**COUNTY OF WESTCHESTER
NEW YORK
DIVISION OF ENGINEERING**

**ADDENDUM NO. 3
CONTRACT NO. 20-530**

**Infrastructure Rehabilitation – Phase 2
Playland Park
Rye, New York**

3 ENLARGED PLAN
GE-E-04 SCALE: 1" = 20'

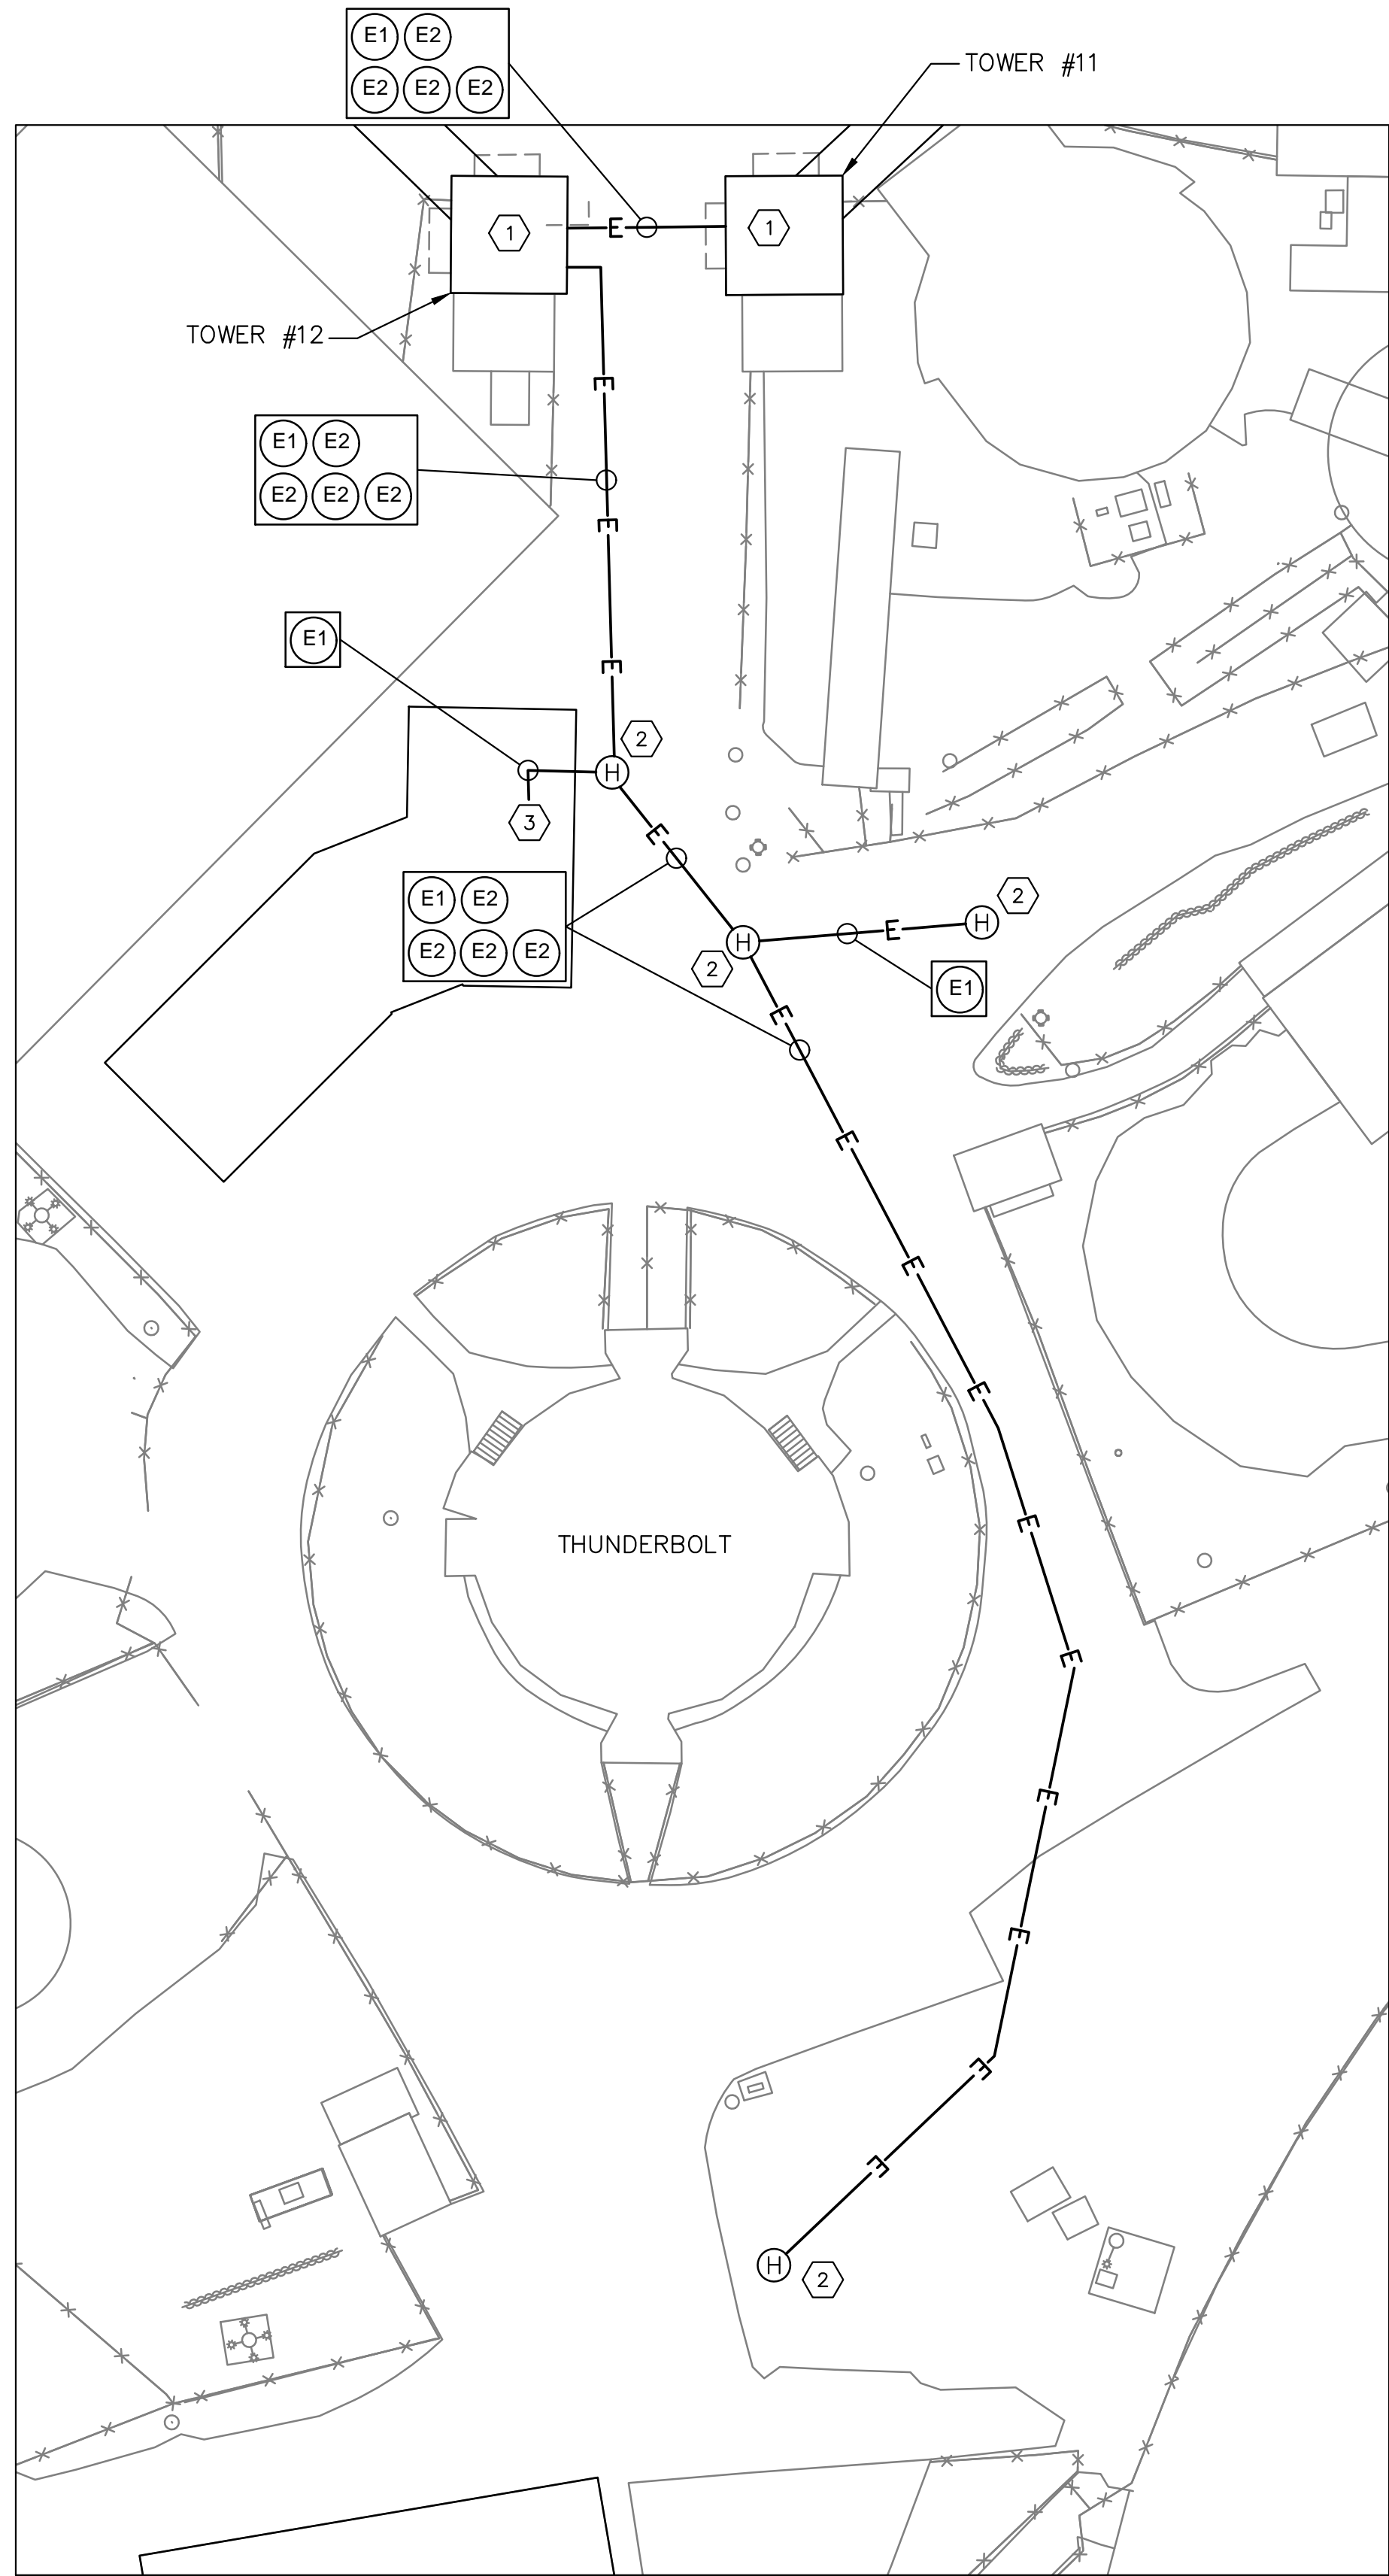
Drawing GE-E-05 (Page 290 of 290)– GENERAL DUCTBANK PLAN-2.

- KEY NOTES:
- TOWER WILL HAVE NEW MANHOLE INSTALLED (SEE MAW-1 ADDENDUM STRUCTURAL DRAWINGS FOR ADDITIONAL INFORMATION). INCOMING UNDERGROUND CONDUIT WILL BE ROUTED TO NEW MANHOLE. CONTRACTOR IS ADVISED, UNDER THE MEGA 1 PROJECT, UNDERGROUND CONDUIT WILL BE INSTALLED AND CAPPED 8" PAST THE TOWER FOOTPRINT. MEGA 2 CONTRACTOR WILL INTERCEPT (AT THIS POINT) AND INSTALL NEW CONDUIT AS SHOWN.
 - PROVIDE 18" X 18" X 24" POLYMER CONCRETE MANHOLE AT THIS LOCATION.
 - INCOMING UNDERGROUND CONDUIT SHALL BE ROUTED TO ATTIC SPACE OF STRUCTURE. CONCEAL EXPOSED CONDUIT AS MUCH AS PRACTICAL. STUB AND CAP CONDUIT FOR FUTURE USE.

CONTRACT No. 20-530
SHEET No. 1 OF 1
DATE: June 29, 2021
NOT TO SCALE
DRAWING No.
AD-A-03

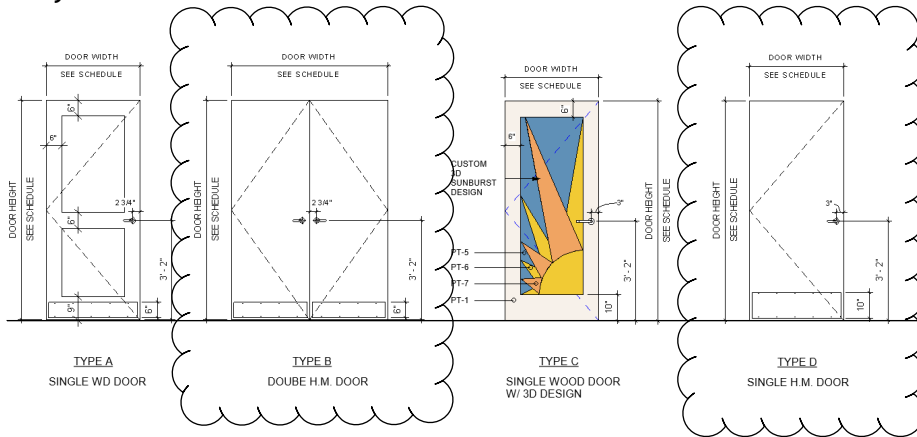
Item 5: Drawing BCR-A-61 (Page 249), Door & Window Schedule and Transition Details.
Modify the Contract drawing as shown on Addendum Drawing AD-A-03, attached.

Modify:

3 EAST PASSAGE EXTERIOR ELEVATION

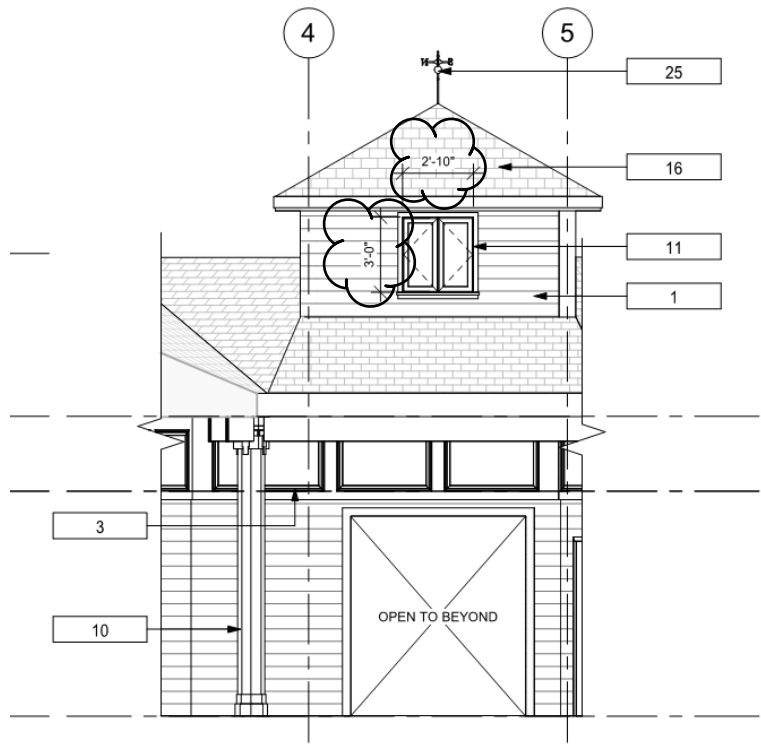
Item 7: Drawing BCR-A-21 (Page 239), Exterior Elevations.

Modify the Contract drawing as shown on Addendum Drawing AD-A-06, attached.

Modify:

⑥ **WB-2 FIBERGLASS BASE DETAIL (INTERIOR)**
N.T.S.

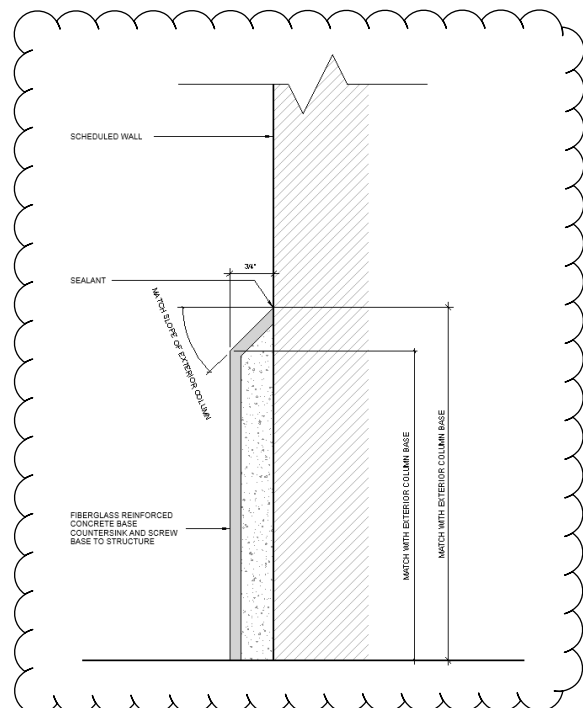
Item 9: Drawing BCR-A-51 (Page 246), Partition and Flooring Type Details
Modify the Contract drawing as shown on Addendum Drawing AD-A-07, attached.

Insert:

CONTRACT NUMBER	SHEET NUMBER
20-530	AD-COL-E-05
DWG NO.: Page 67 of 290	
SCALE: AS SHOWN	
DATE: MAY 26, 2021	
DPW FILE NUMBER	REV. NO.
1-118-E-454	0

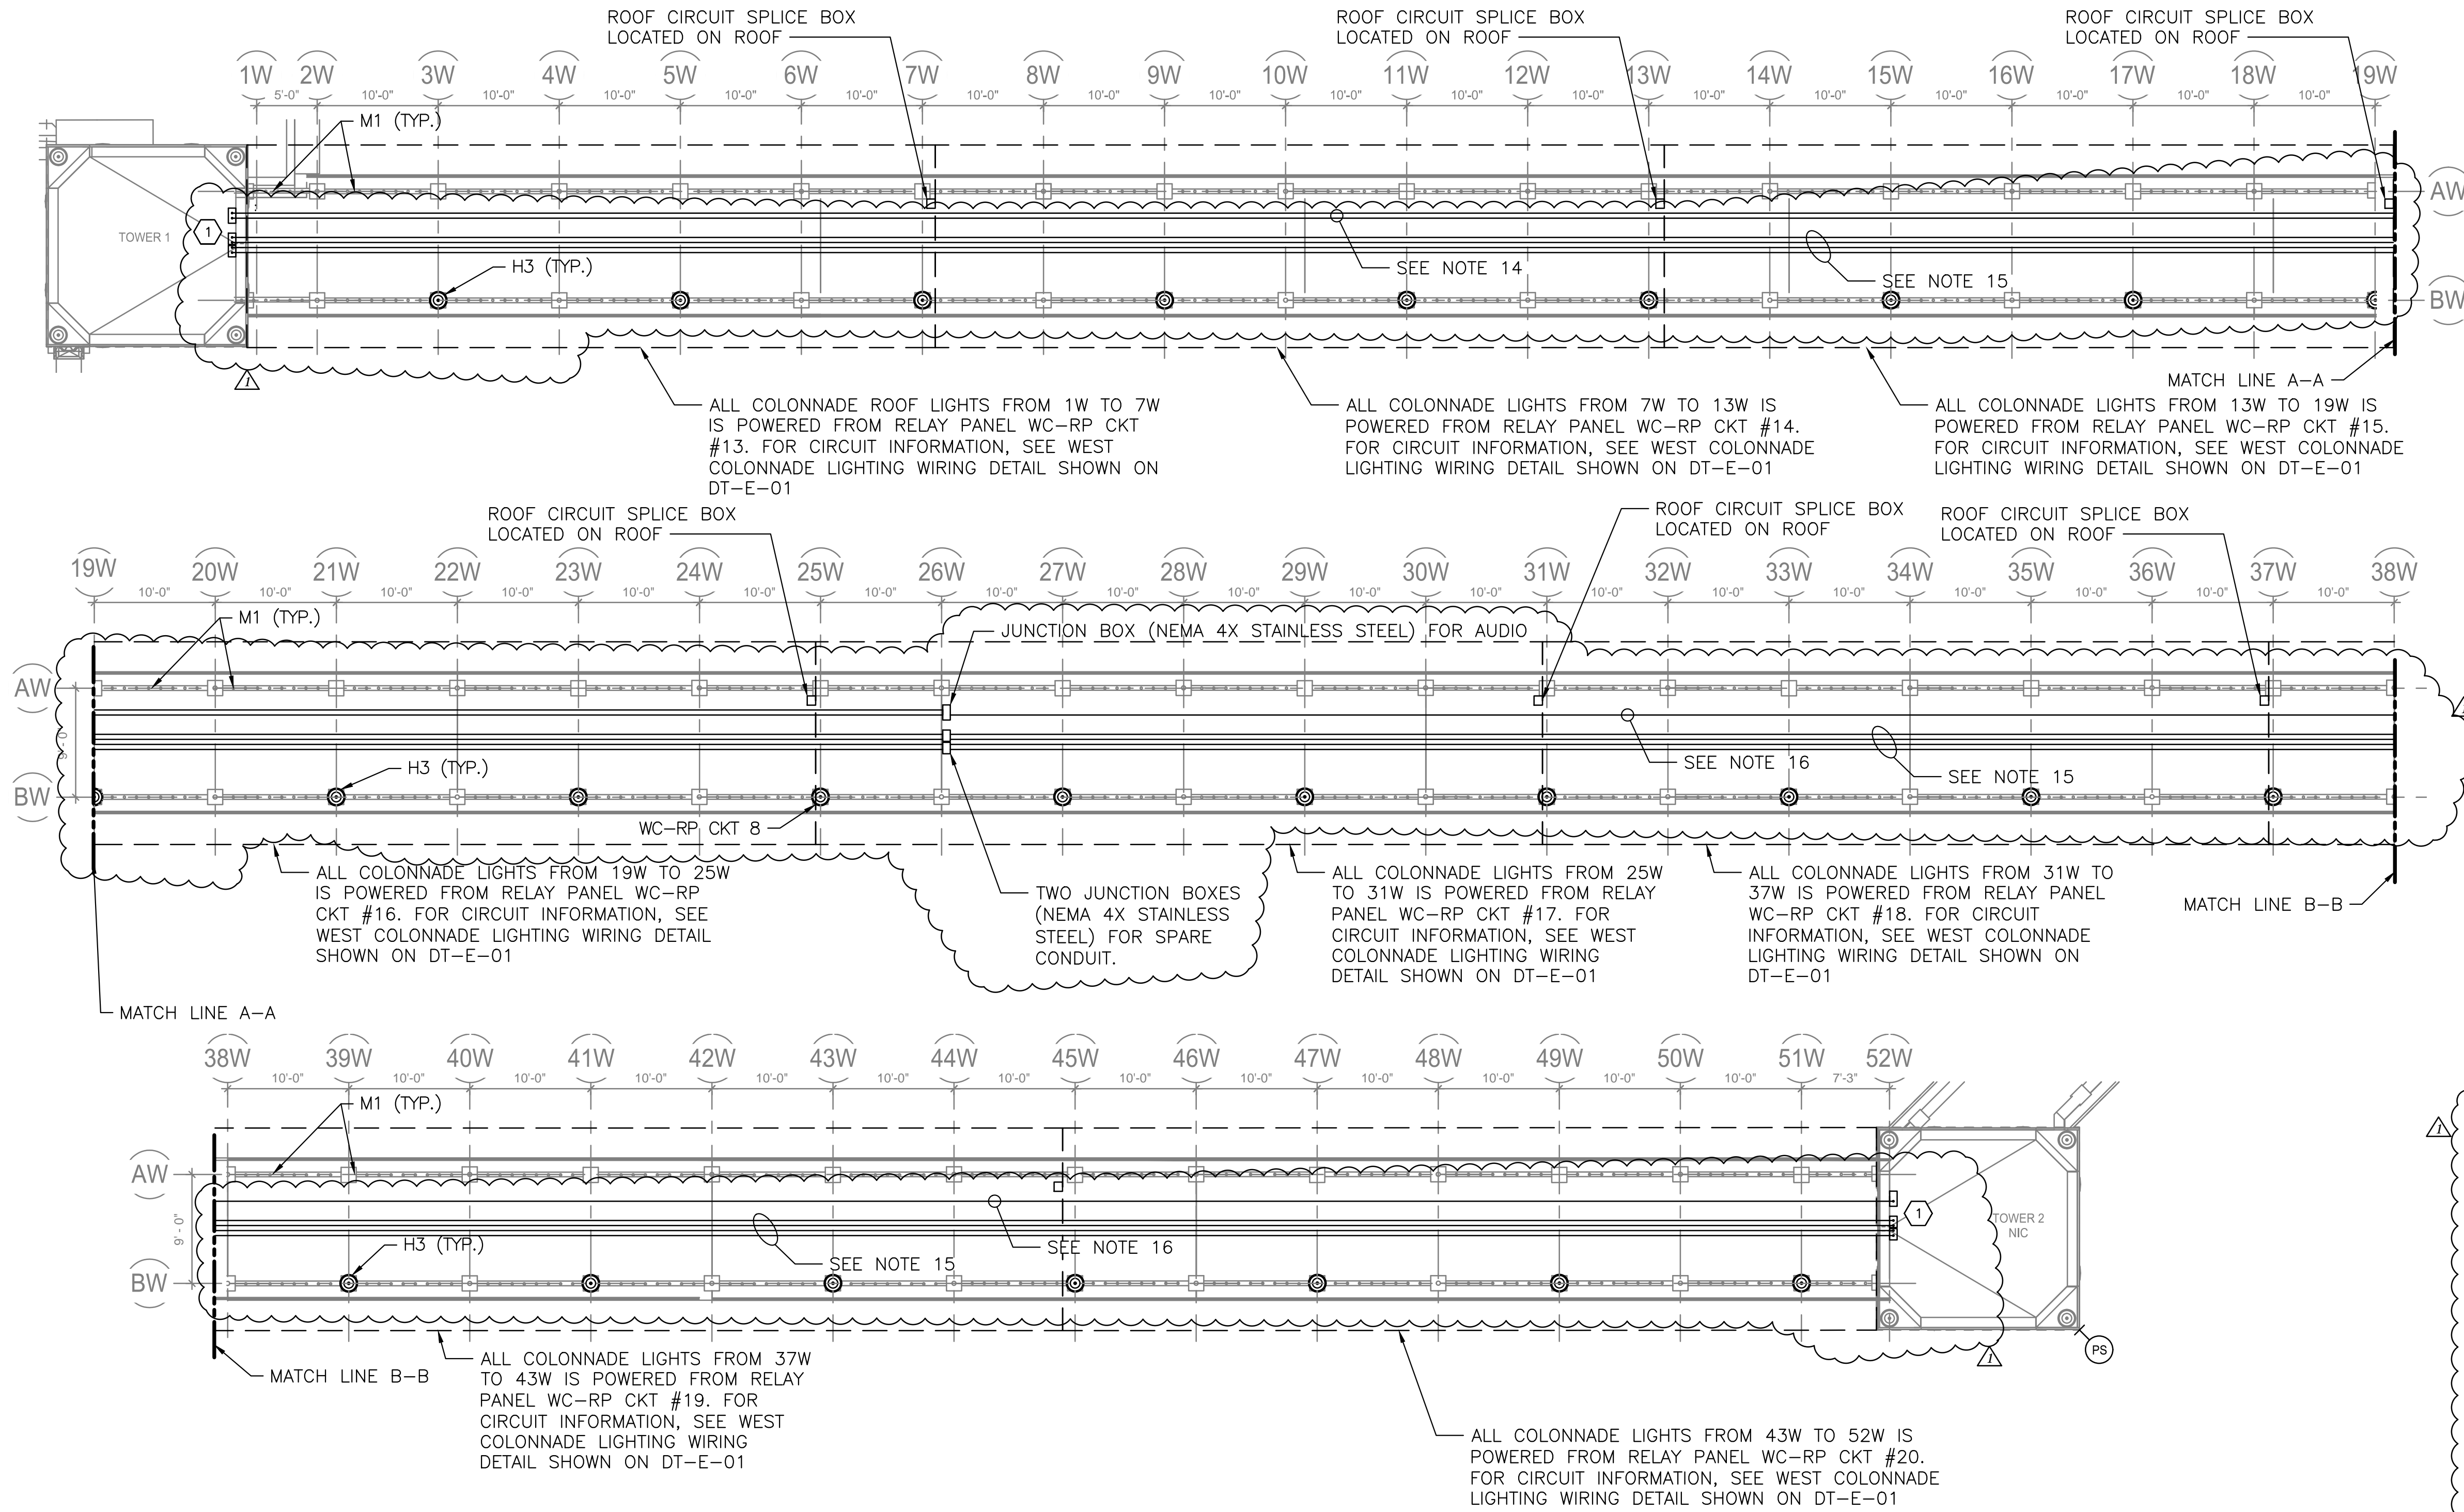
Item 10: Drawing COL-E-05 (Page 67), West Colonnade Roof Lighting Plan
Modify the Contract drawing as shown on Addendum Drawing AD-COL-E-05, attached.
